**PSE&G** Public Service  
Electric and Gas  
Company

August 20, 1984

HOPE CREEK GENERATING STATION  
DOCKET NO. 50-354  
DRAFT SAFETY EVALUATION REPORT  
OPEN ITEM STATUS

Attachment 1 is a current list which provides a status of the open items identified in Section 1.7 of the Draft Safety Evaluation Report (SER). Items identified as "complete" are those for which PSE&G has provided responses and no confirmation of status has been received from the staff. We will consider these items closed unless notified otherwise. In order to permit timely resolution of items identified as "complete" which may not be resolved to the staff's satisfaction, please provide a specific description of the issue which remains to be resolved.

FIGURE 220.21-9

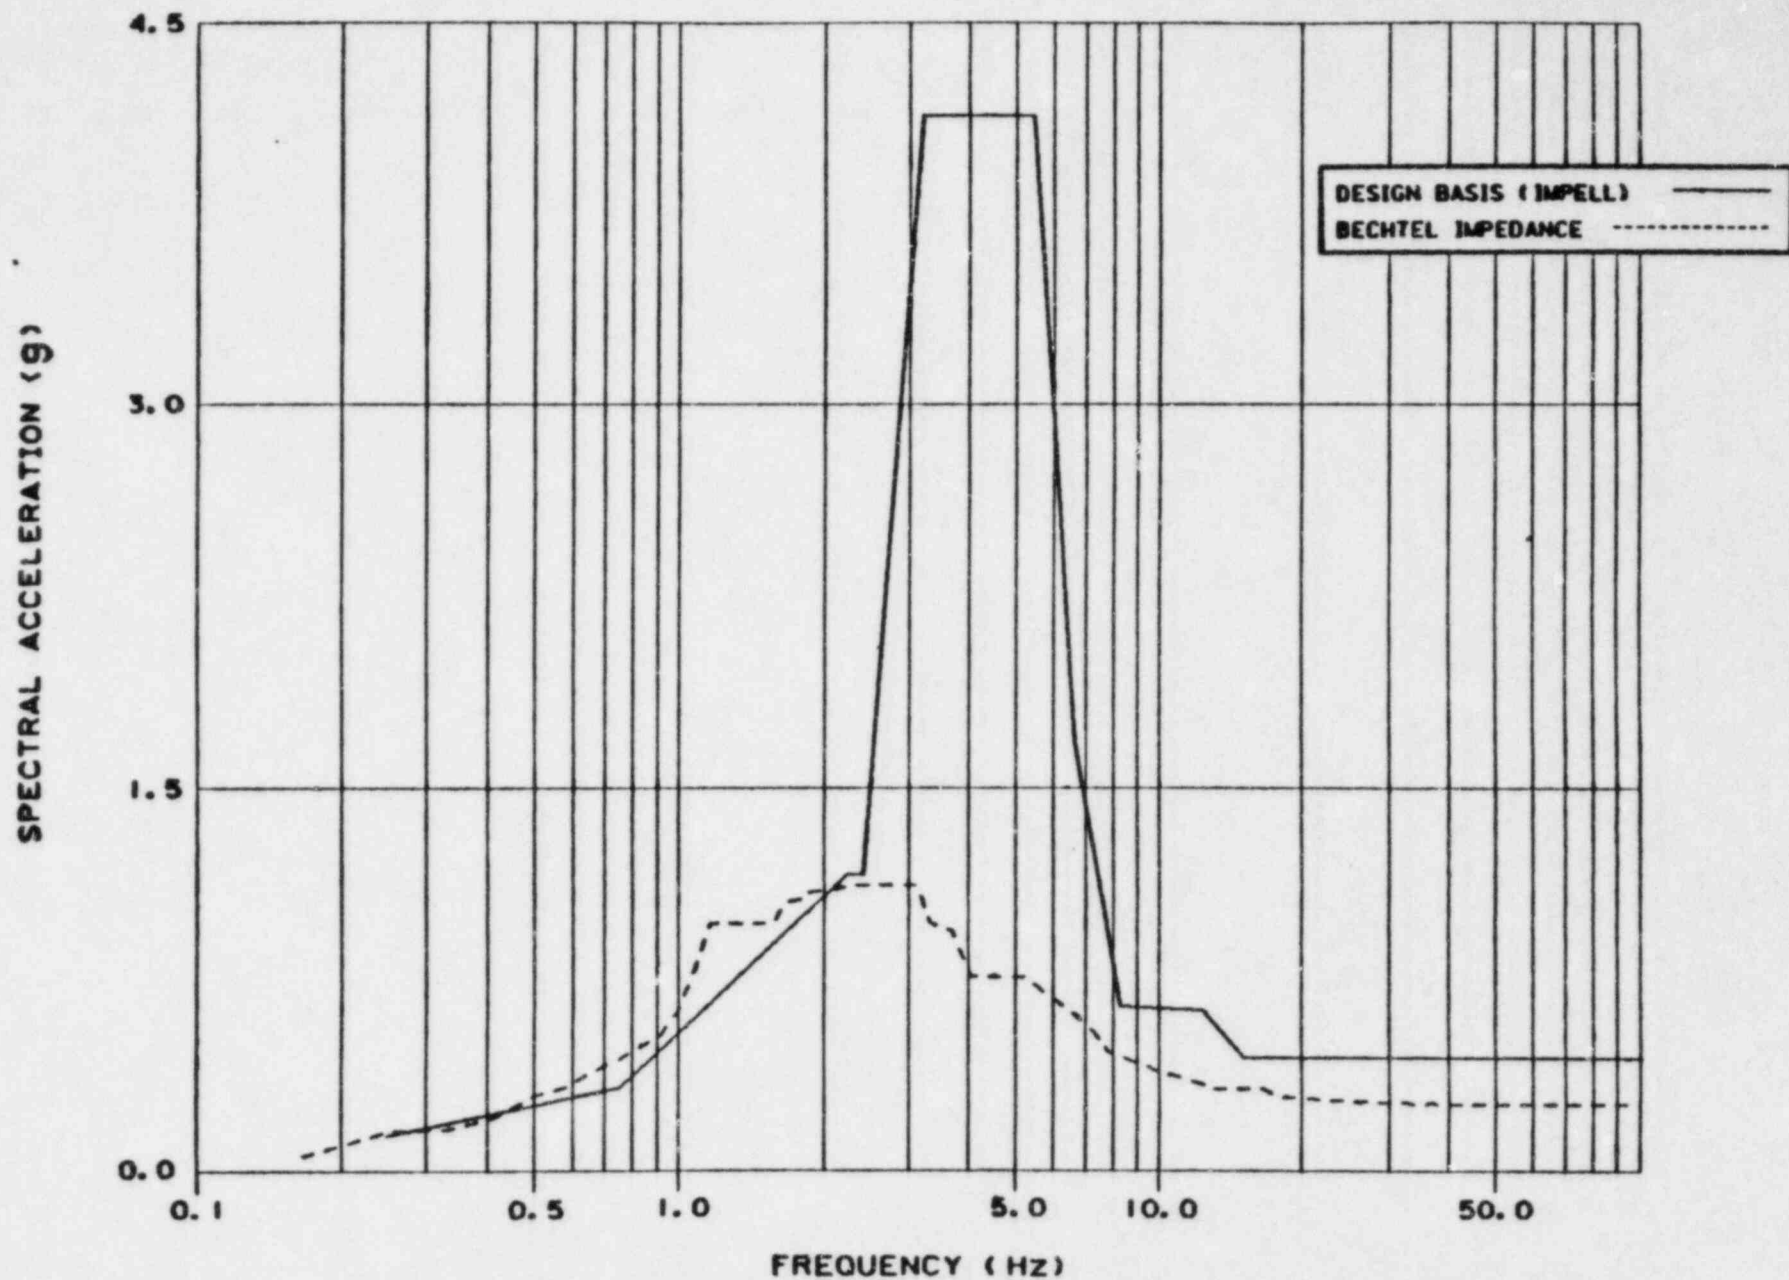
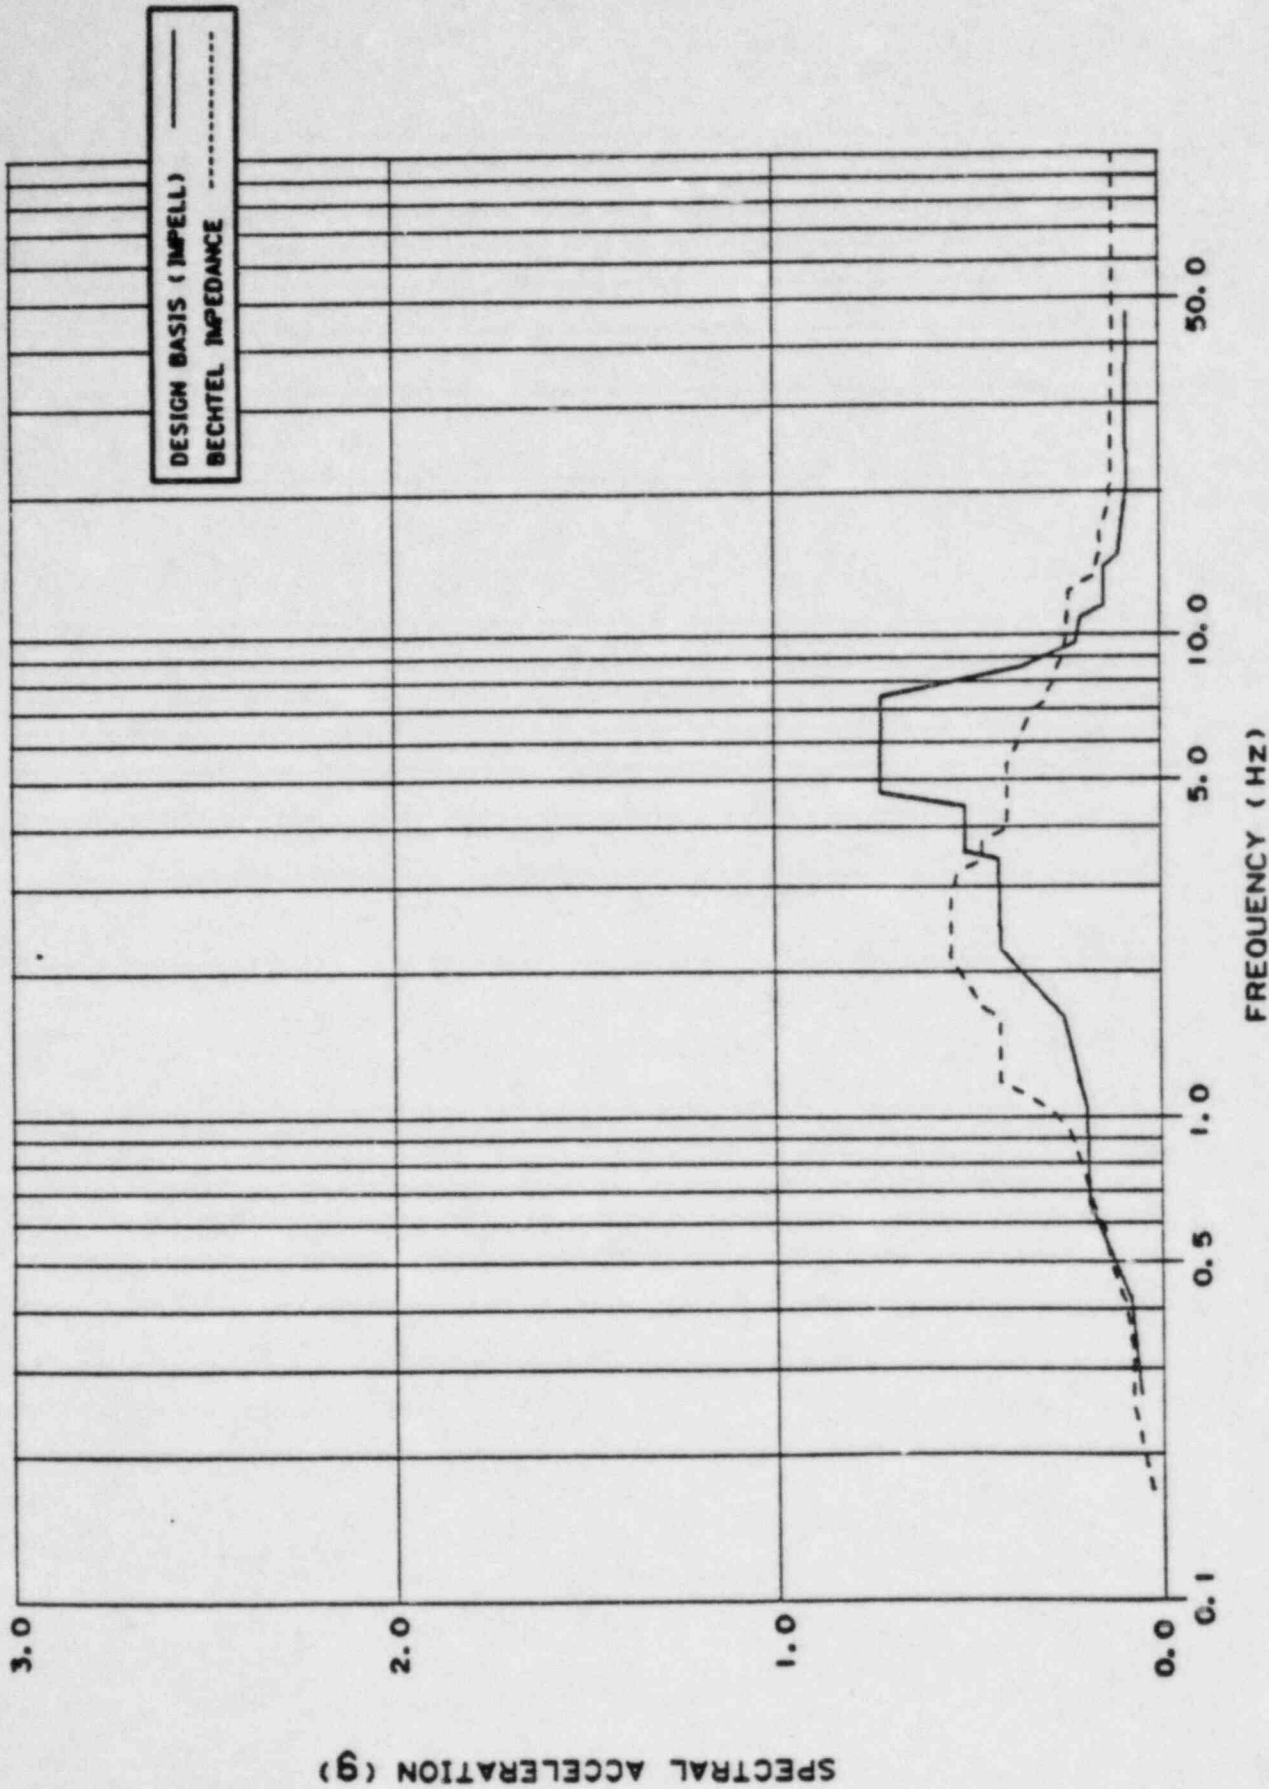
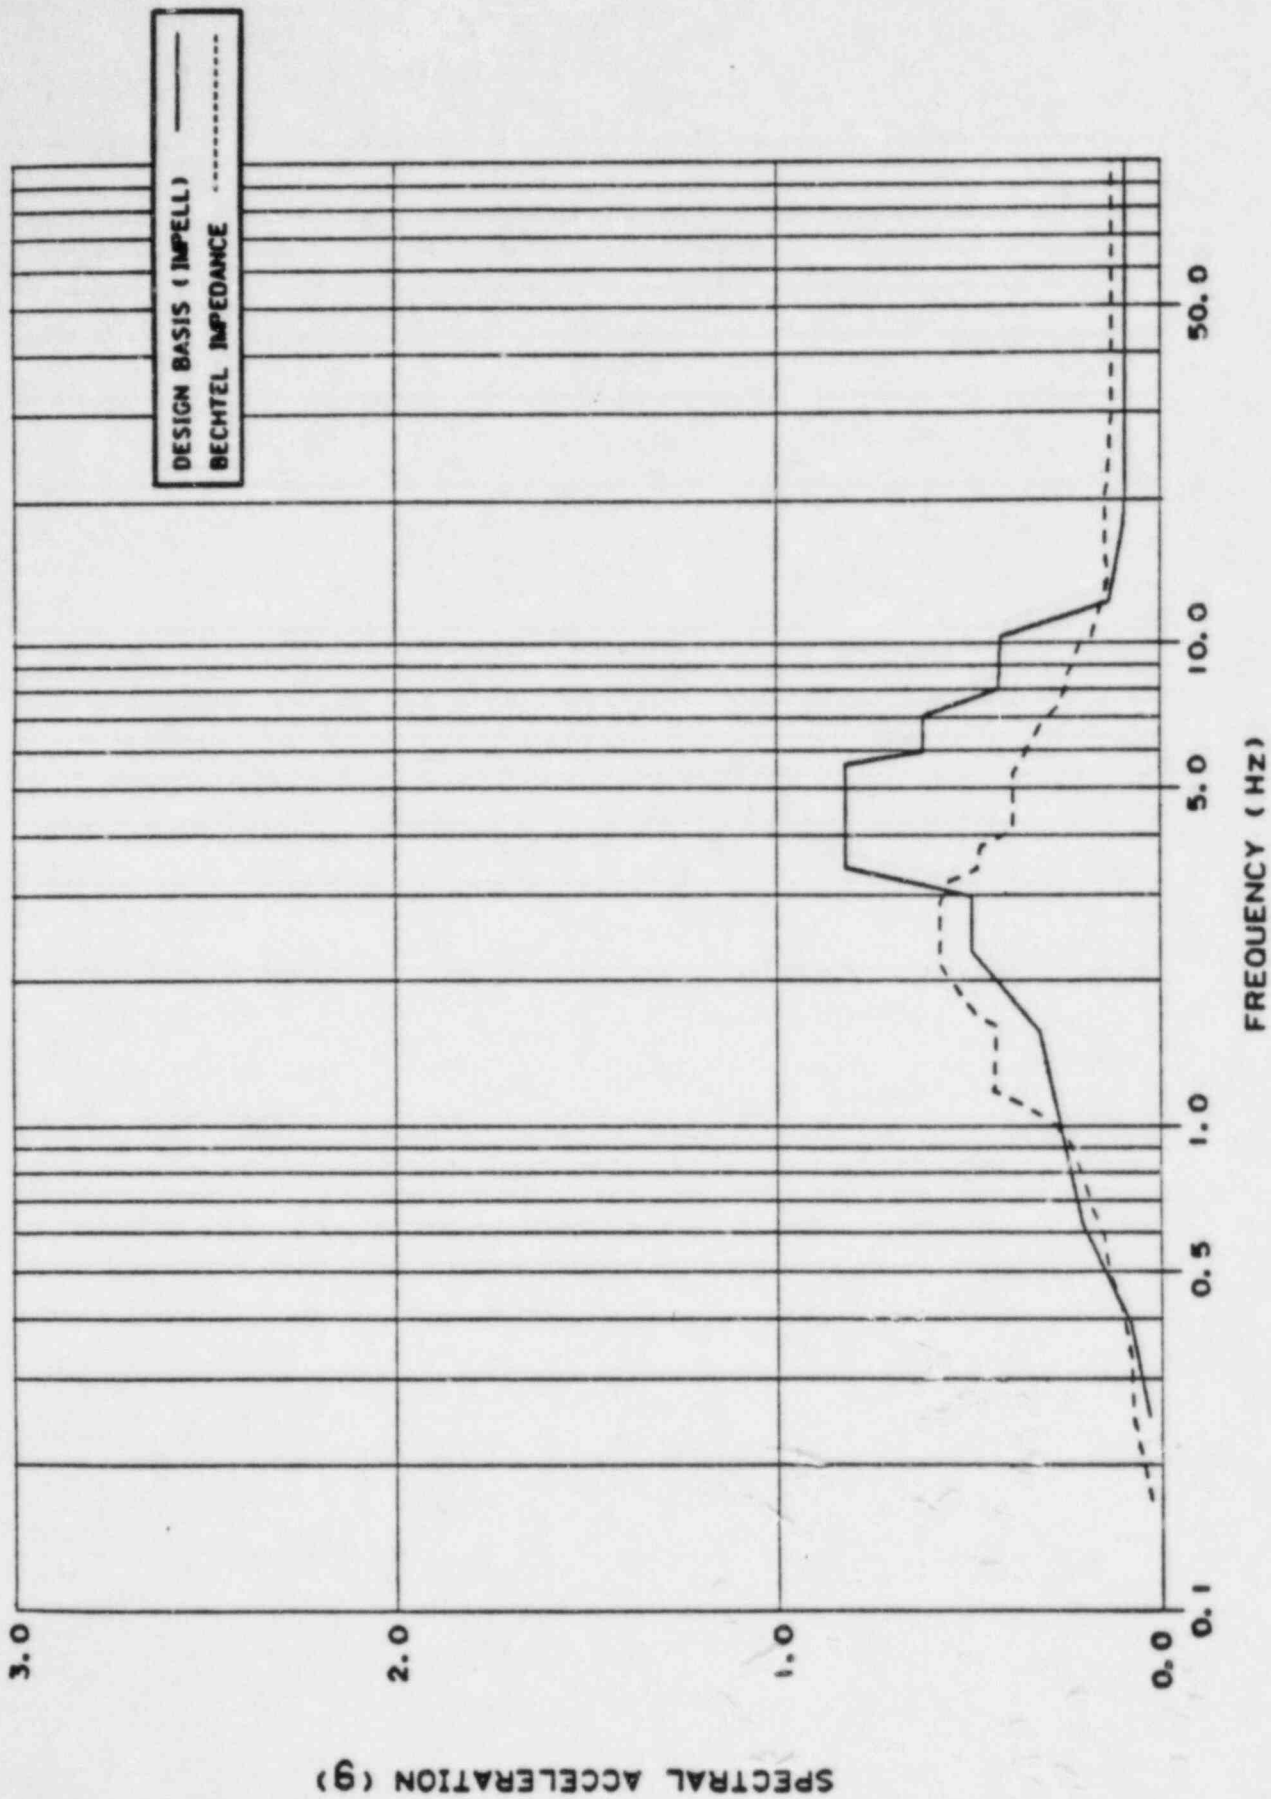
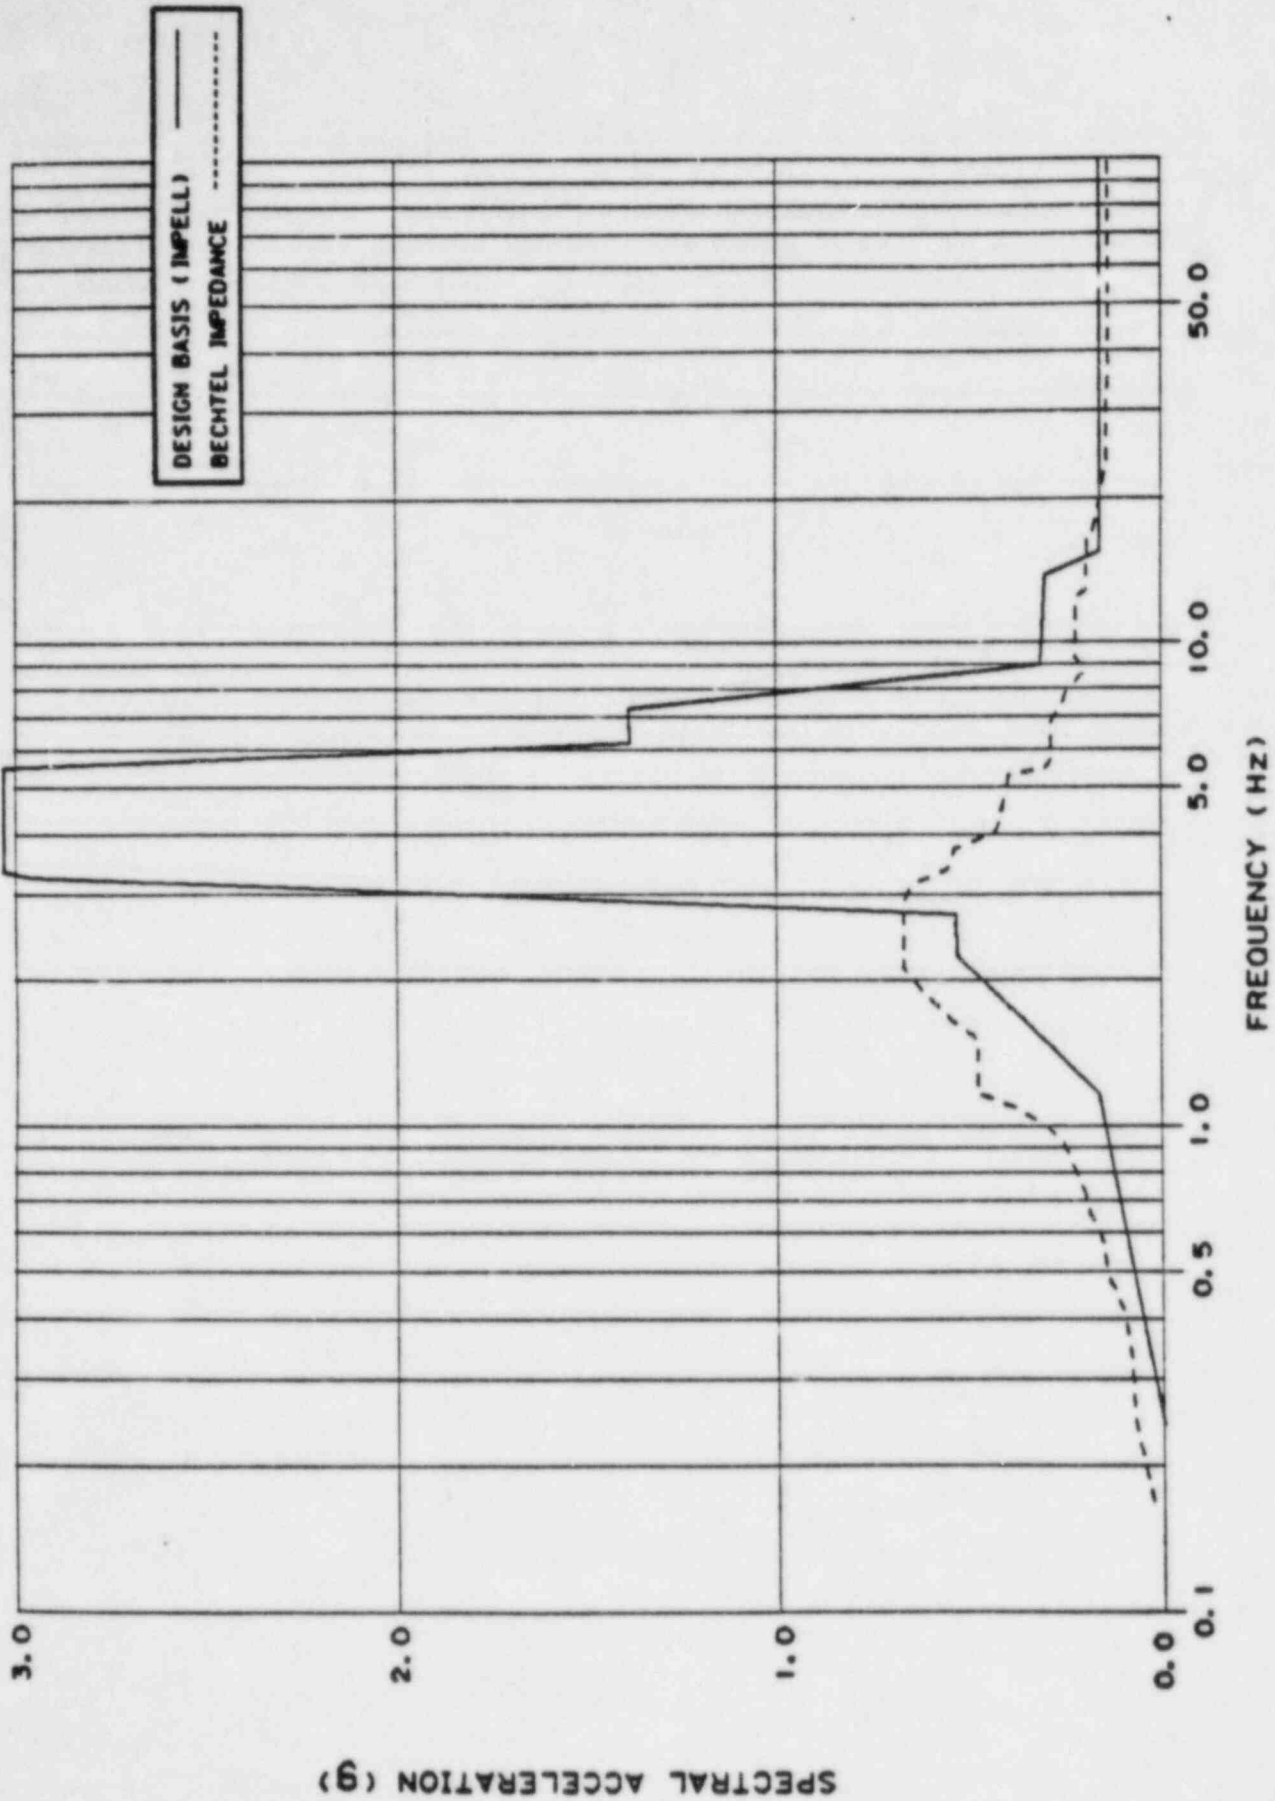
Figures 220.21-1 through 220.21-54 show a comparison of the 2 percent damping response spectra obtained from the design basis finite element and the impedance analyses for the reactor building, auxiliary building and the service water intake structure (SWIS).

¶ For the reactor and auxiliary buildings, the peak spectral accelerations obtained from the impedance analysis are generally lower than those obtained from the design basis analysis. However, the impedance analysis response spectra are not completely enveloped by those obtained from the design basis analysis, especially in the frequency range from 1.0 to 3.5 Hz. Also, there are some local exceedances in the higher frequency range, as shown in Figures 220.21-1 through 220.21-36. ¶ For the SWIS (Figures 220.21-37 through 220.21-54), the impedance analysis response spectra are generally enveloped by those obtained from the design basis analysis at elevation 114.0 feet. For other elevations, the impedance analysis spectral accelerations exceed the design basis spectral accelerations in some frequency ranges. These ranges vary approximately between 1.5 and 10.0 Hz.

In all cases, the items reviewed during these sampling studies can accommodate the loads resulting from the impedance analysis. Therefore, the impedance analysis results have no impact on the plant design.
